PACKARD DIVISION

STUDEBAKER-PACKARD CORPORATION

Counselor

AUGUST, 1955

Engine Runaway— Low to High Shifts

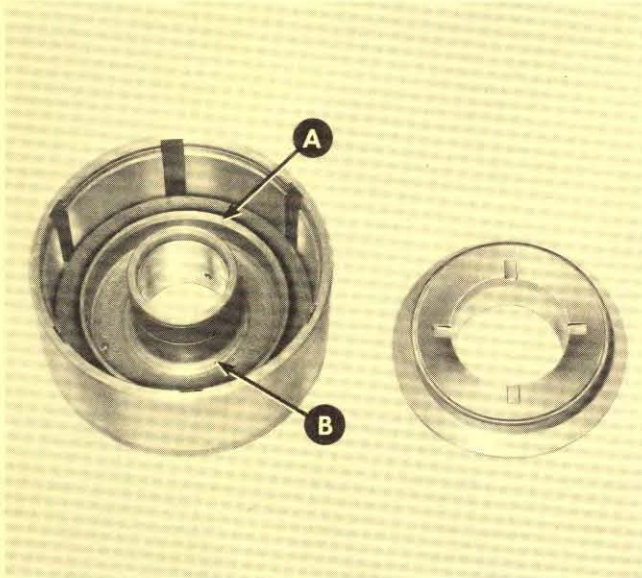
Engine runaway during low to high shifts has been reported on a few 55th Series cars, that could not be corrected by changing the throttle rod adjustment to raise the throttle pressure in the transmission.

In some instances, it has been found that the high range clutch piston in the released position rests on the milled surface indicated by "B" in the illustration restricting the oil pressure to the back of the piston causing slow engagement of the clutch.

When the piston is in its released position, the flange on the piston should rest on the shoulder "A" in the high range clutch housing, leaving .031" clearance between the end of the piston and the milled surface marked "B" which provides a means for the oil pressure to engage the clutch.

If the piston is found to be touching or resting on the milled surface "B" in the clutch housing, oil passages can be provided by filing four grooves in the piston as shown.

Using the edge of a 12" file, carefully file four grooves equally spaced 1/16" deep and 1/4" outward from the chamfered center hole in the piston.

Horn Button Contact

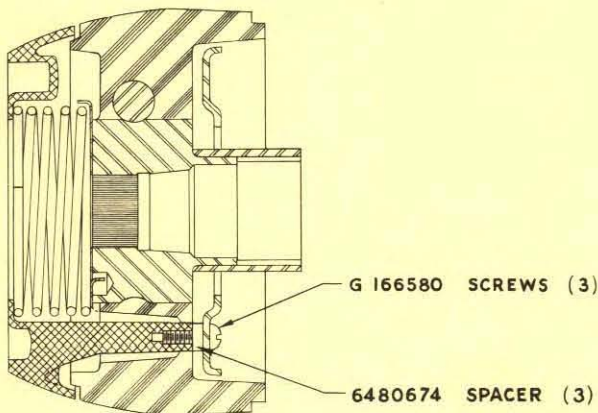
A few reports have been received of the horn button not making contact when the horn ring is pushed down at the location in line with the spoke of the steering wheel.

This condition can be corrected by installing spacers and longer screws between the steering wheel and the horn ring contact plate as follows:

2. Remove the three screws that attaches the contact plate to the steering wheel, install the three spacers No. 6480674 behind the plate and secure the plate with the three new longer screws No. G-166580. "See illustration."
